November 1st, 2019

Re: Agnico Eagle's response to Meadowbank (2AM-MEA1526) and Whale Tail (2AM-WTP1826) 2018 Annual Report comments

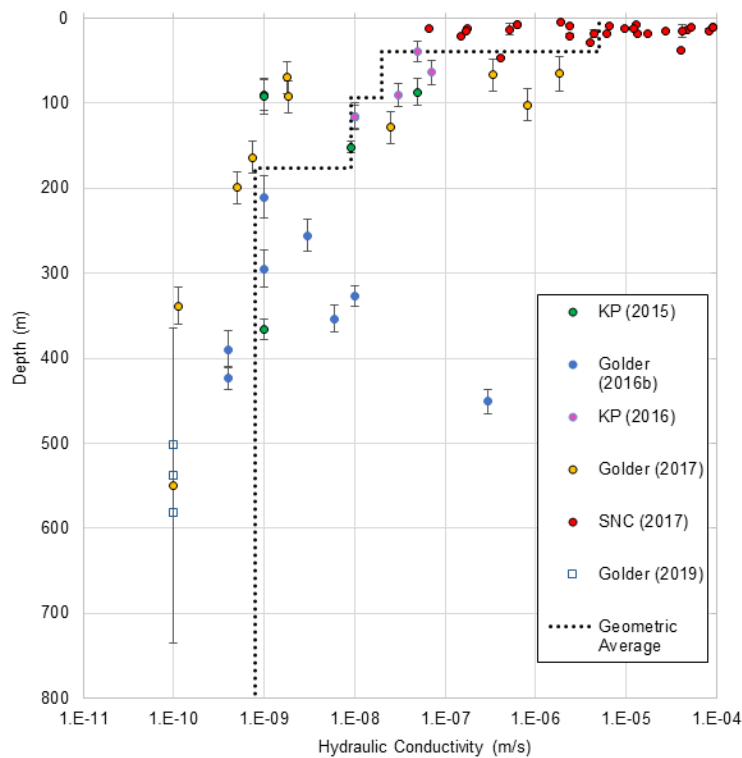
...A hydrogeological testing program was conducted between 7 and 9 of December 2018...The testing was conducted in deep bedrock in the subpermafrost zone over a depth interval of about 375 m to 626 m below ground surface. All three of these tests resulted in estimated hydraulic conductivities of less than 1×10^{-10} m/s... the one high value of hydraulic conductivity over a 30 m zone from a depth of about 436 m to 466 m in deep

bedrock that was measured during the drilling of the borehole for the Westbay multi-level well is likely an isolated zone of jointing near the test interval...

The amount of jointing at the Whale Tail Site is unknown. Permafrost restricts groundwater flow. However, Groundwater Monitoring Plan Version 2.1 projects the majority of permafrost under the pit lake will thaw after closure.

Since submission of the FEIS for the Approved project, a significant number of additional measurements of bedrock hydraulic conductivity have been made to verify assumptions in the modelling and improve the accuracy of model predictions. Figure below presents a summary of measurements made to date, which includes 58 measurements in unfrozen rock between 2015 and 2019.
